Olympus reference: QIL FY25-EMEA-28-FY25-013 Guide Sheath Component**URGENT: FIELD SAFETY NOTICE****RE: Single Use Guide Sheath Kit****Attention:** Endoscopy Department, Bronchoscopy Suite, Pulmonology, Risk Management

Olympus is writing to inform you of a Field Corrective Action pertaining to the Single Use Guide Sheath Kits, models K-201, K-202, K-203, and K-204. These instruments have been designed to be used with an Olympus endoscope to collect cells or tissue specimens in the respiratory organs.

Figure 1: Single Use Guide Sheath (models SG-200C and SG-201C)

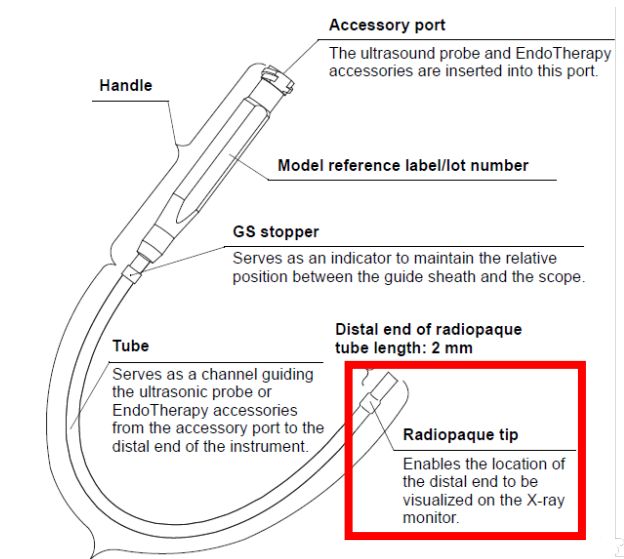
Olympus conducted an investigation into the Single Use Guide Sheath Kits after receiving complaints that the radiopaque tip of the guide sheath component (see Figure 1 below), fell off into the patient. Since July 2021, Olympus has received 32 complaints involving intraoperative disassociation of the guide sheath radiopaque tip in which the tip fell off into the patient. Of these 32 complaints, 26 were reported as serious injuries, and 6 were reported as malfunctions. The preliminary findings from Olympus' investigation have identified that the disassociation of the tip from the guide sheath is likely the result of excessive force applied when inserting instruments into the guide sheath, and/or damage to the distal end of the sheath.

Olympus has launched the next generation of the Single Use Guide Sheath Kits, models K-401, K-402, K-403, and K-404, which has a different radiopaque tip design. Therefore, Olympus has discontinued the previous generation models (K-201, K-202, K-203, and K-204) and is removing these models from the market.

You should stop using the K-201, K-202, K-203, and K-204 Single Use Guide Sheath Kits as soon as possible. The next generation Single Use Guide Sheath Kits, models K-401, K-402, K-403, and K-404, should be used by your facility instead.
